Meeting: 19th July 2022

Item No: 6

Report under Part 8 Planning and Development Regulations 2001
Proposed development of Site at Shangan Road.

Planning Ref 3926/22

1 Proposed Site Plan
Scale: 1:500

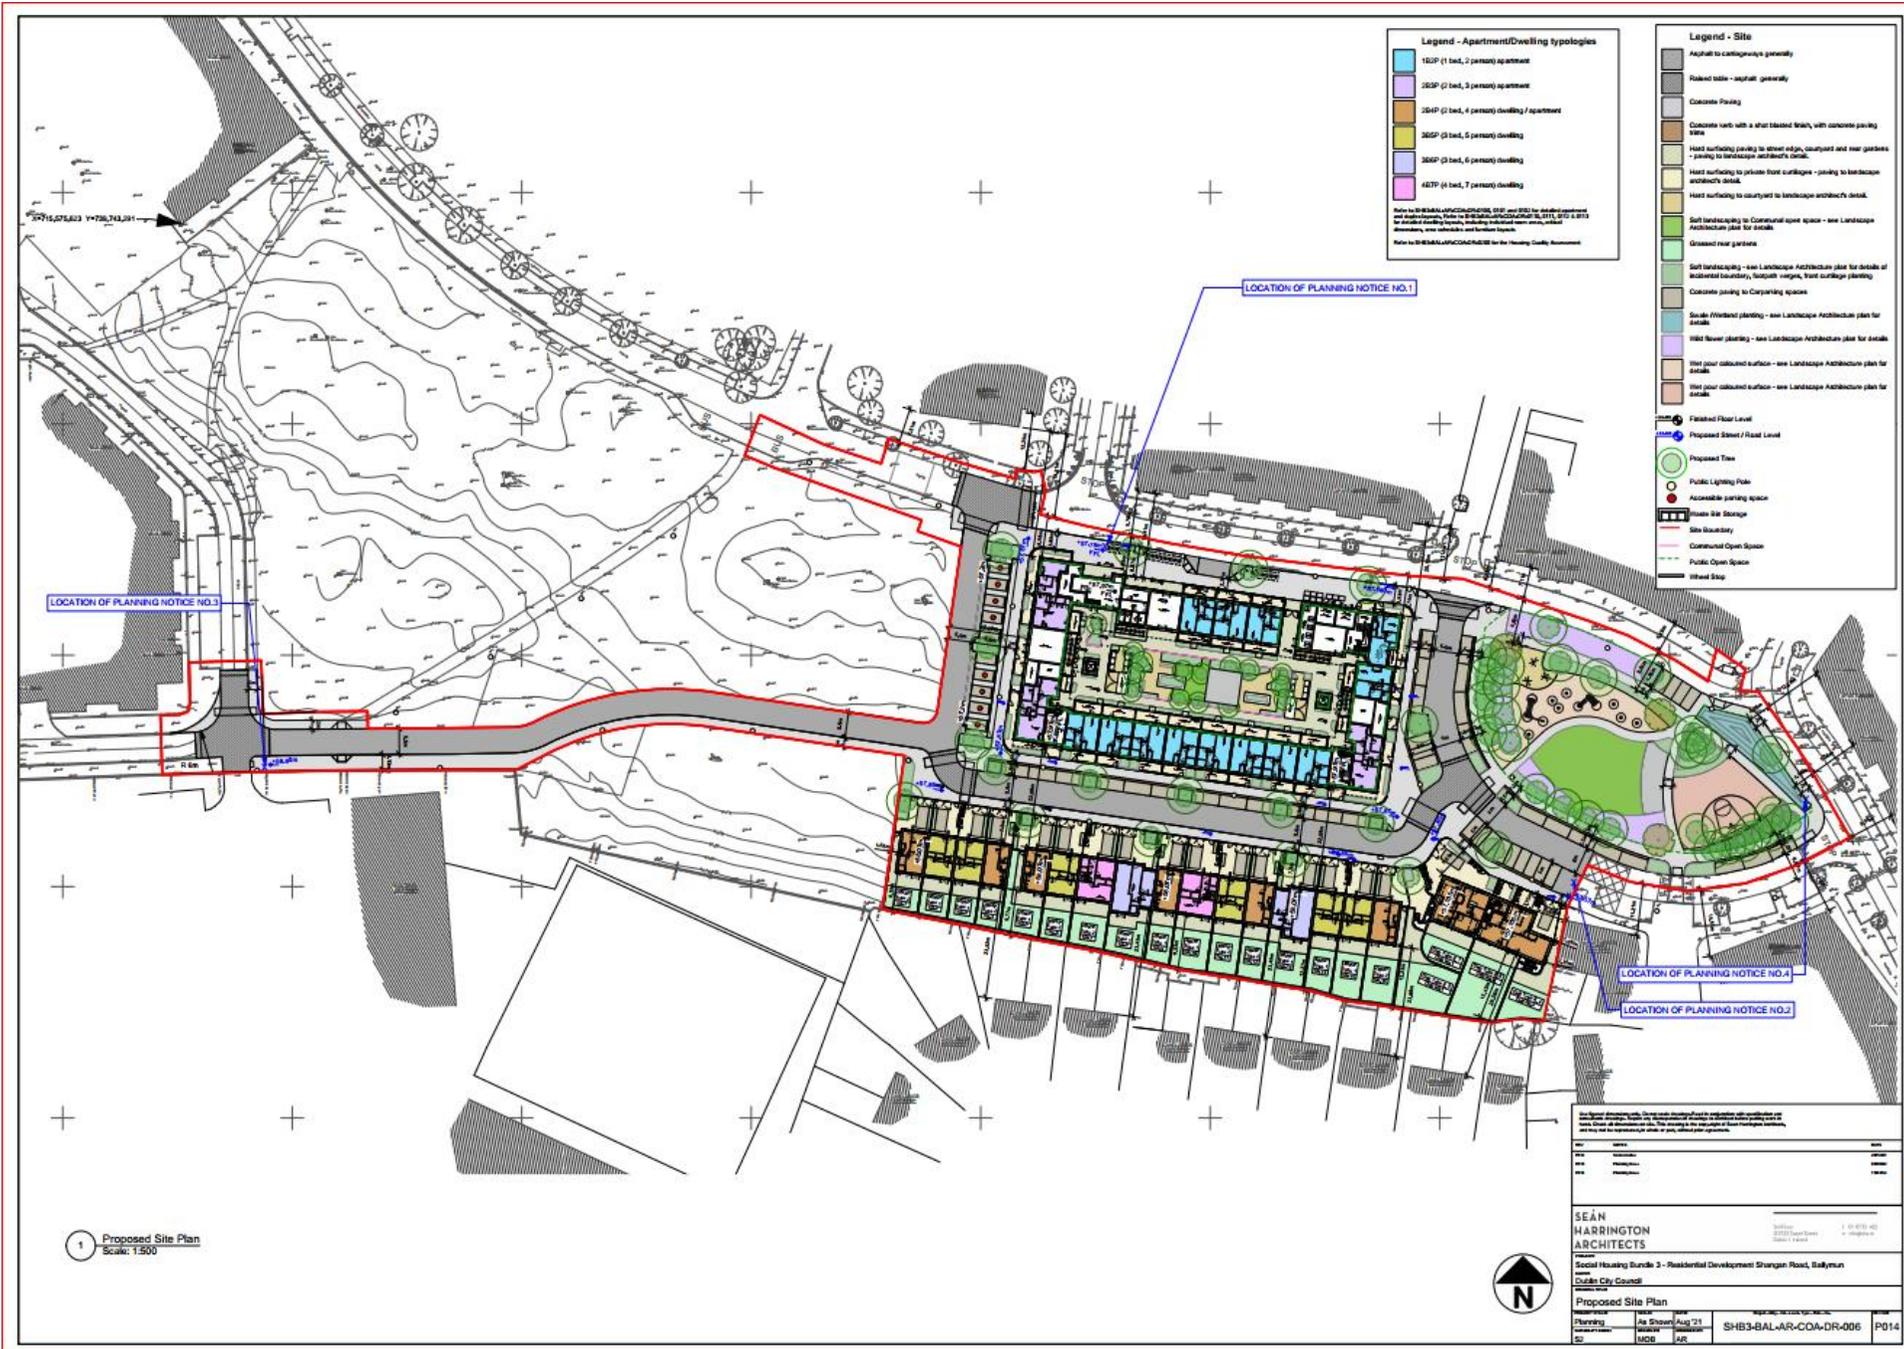
- Great to see development of the site
- Some concern from residents in Oldtown re overlooking and overshadowing
- The security on the playground beside Longdale is queried
- The future plans for the rest of the site is questioned

(i) The proposed site layout plan shall ensure compliance with the Design Manual for Urban Roads and Streets, 2013 as amended (2019) and in particular, all perpendicular car parking spaces shall incorporate a wheel stoppers to protect the pedestrian footway.

- Some concern from residents in Oldtown re overlooking and overshadowing

It is considered that the most sensitive properties in relation to any potential overlooking would be the established two-storey houses on Oldtown Avenue, located immediately to the south of the site, where the rear gardens of same back onto this application site. It is noted that minimum 22 metre separation distances are proposed between the rear elevations of the new two-storey dwellings and the elevations of the proposed duplex units and the rear of the existing two-storey dwellings along Oldtown Avenue i.e. nos. 43 – 73a (odd only). The dwellings proposed are two-storey. The separation distances are adequate and comply with development plan requirements to ensure privacy levels are not unduly impacted upon. As the proposed development is located to the north of these established dwellings. The closest dwellings, two-storey in nature, will not lead to overshadowing of existing rear gardens on Oldtown Avenue. Site 10 is at a higher level to the rear gardens of Oldtown Avenue however it is proposed to install a 2.0m high post a panel fence on the high side to eliminate potential overlooking. Discussion will take place with residents closer to construction to resolve any possible boundary concerns.
